SUNDRY NOTICES AND REPORTS ON WELLS

Plugging Procedure Federal 23 #2 API No. 30-041-00196 N-23-07S-33E 660 FSL 1980 FWL

Federal 23 2 30-041-00196 Ridgeway Arizona Oil Corp

- Conditions of Approval

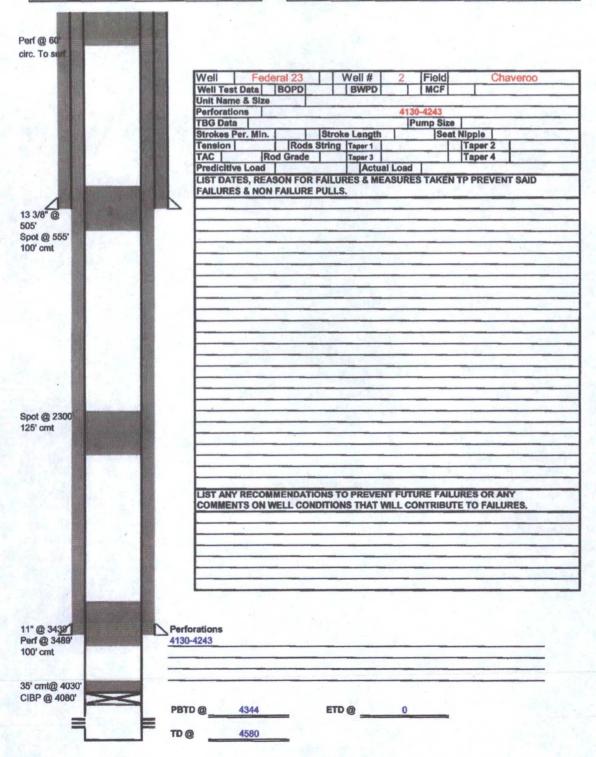
1. Operator shall place CIBP at 4,080' (50'-100' above top most perf) and place 35' of Class C cement on top as proposed. WOC and TAG.

2. Operator shall perf and squeeze at 3,489 (50' below casing shoe) tagging plug at a minimum of 3,389' to seal the intermediate casing shoe
- 3. Operator shall perf and squeeze at 2,300'as proposed. Operator shall place a balanced Class C cement plug from 2,300'-2,175' to seal the top of the Yates formation. WOC and TAG.
- 4. Operator shall perf and squeeze at 555'as proposed tagging plug at 455' to seal the surface shoe.
- 5. Operator shall place a balanced Class C cement plug from 60'- surface as proposed
- 6. See Attached for general plugging stipulations.
